Our Ref: JBS40913-50138 Revision 1

Response to NSW Planning and Infrastructure Letter 'Macdonaldtown Gasworks Remediation Project (09-0145), EA Adequacy Review – Second Round', Revision 1

Figure 1: Macdonaldtown Remediation Proposed Site Setup

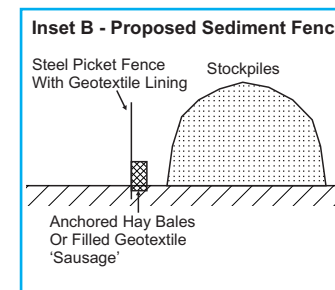
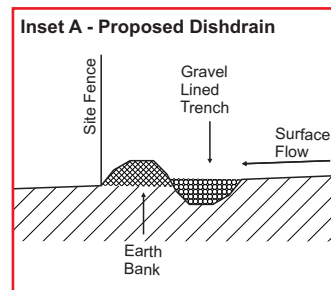
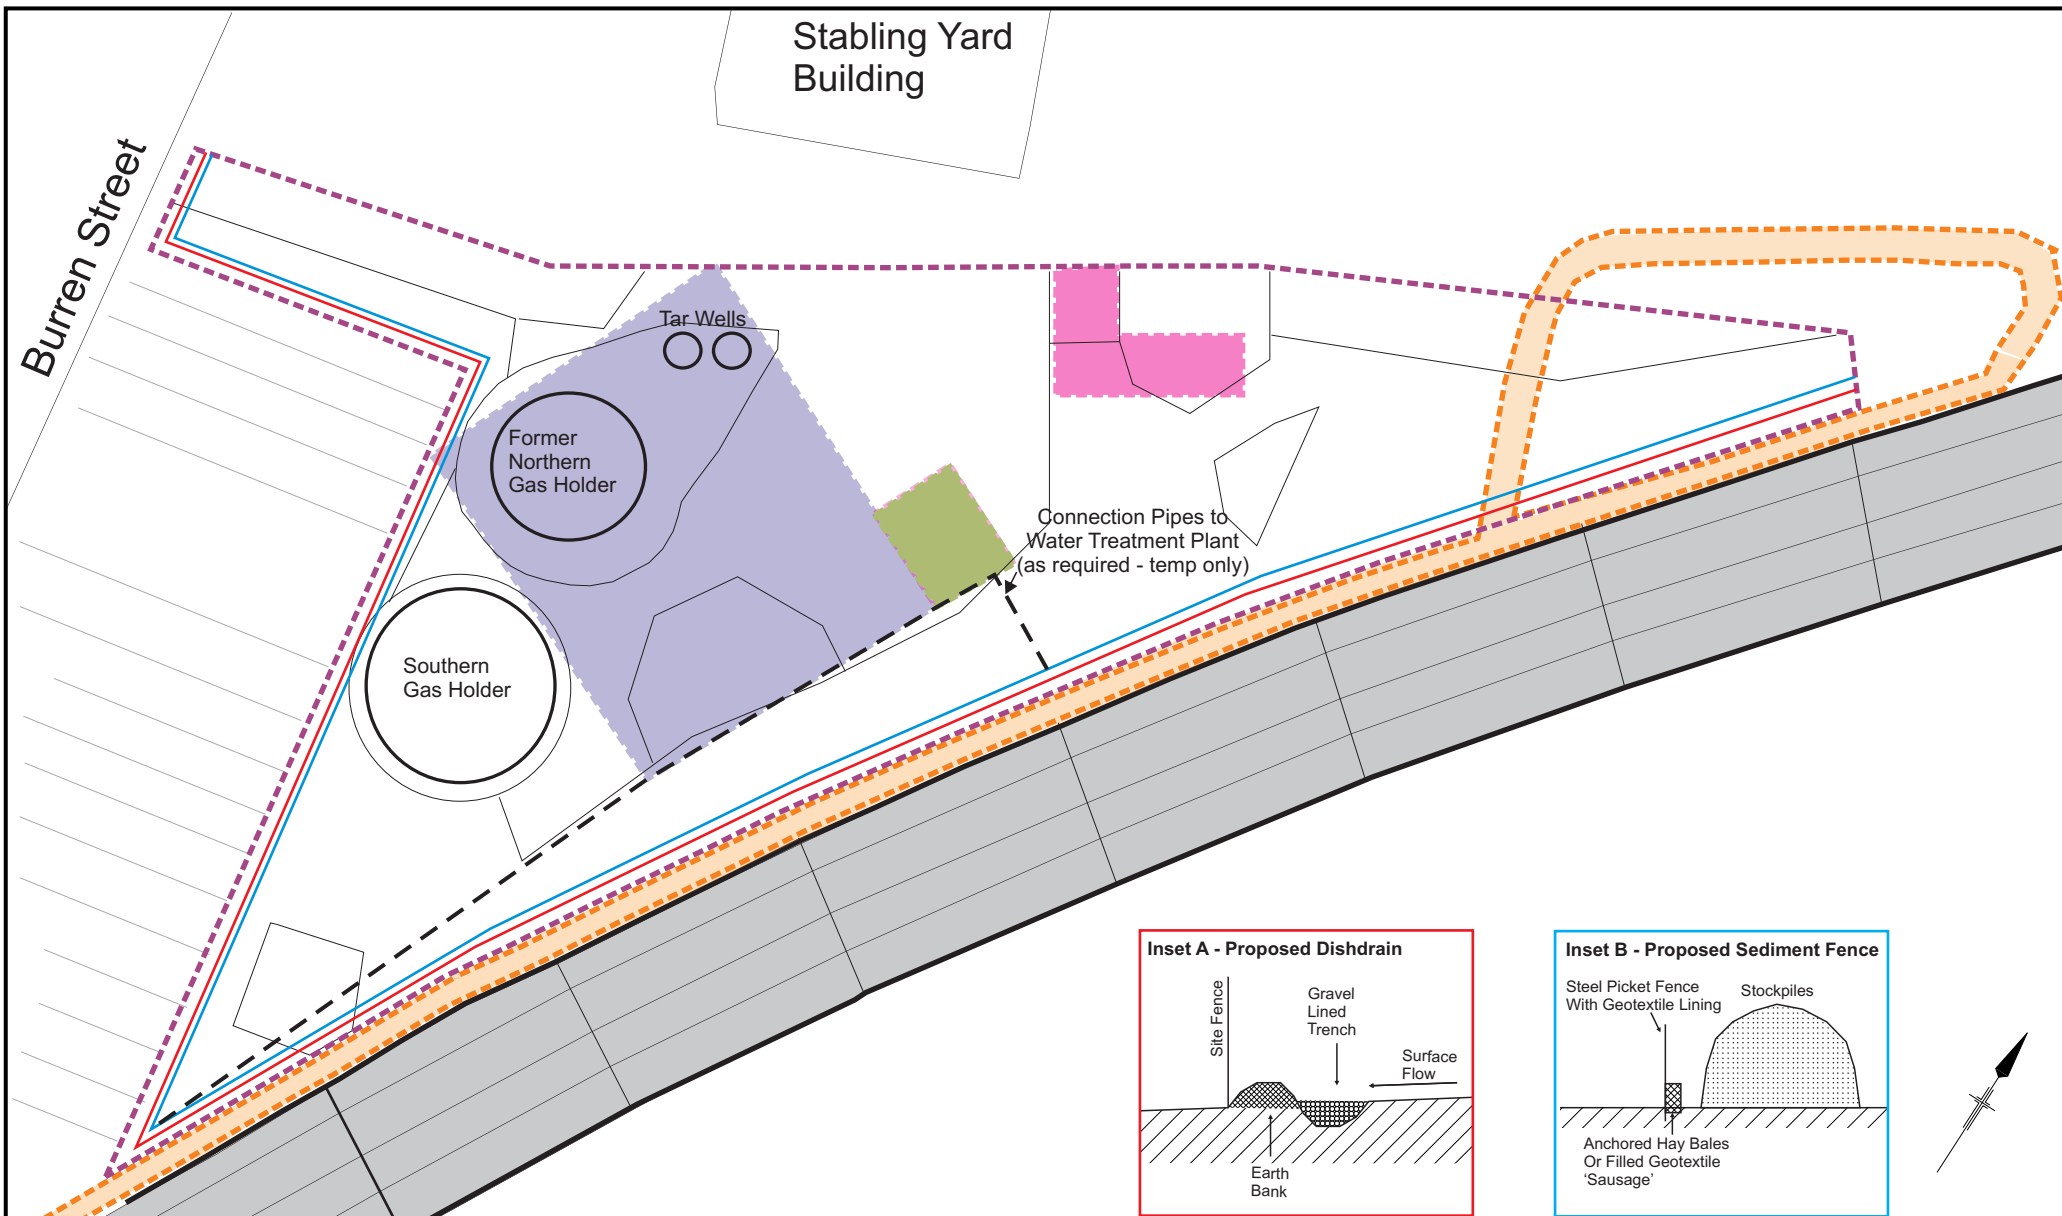
Comment 3: Soil and Water – please also provide a conceptual plan of the stormwater management at each site.

It is proposed that stormwater management be undertaken in accordance with '*Environmental Management Plan, Demolition and Remediation, Former Macdonaldtown Gasworks, Burren Street, Erskineville, NSW*', (JBS 2011e). Specifically EMP Procedures 11 and 30 in JBS (2011e) provide management procedures for stormwater and sediment control during the proposed works. **Figures 1 and 2 (Attachment 3)** provide a conceptual plan of stormwater controls at each site, in accordance with EMP Procedures 11 and 30, and based on the proposed layout at each site during remediation.
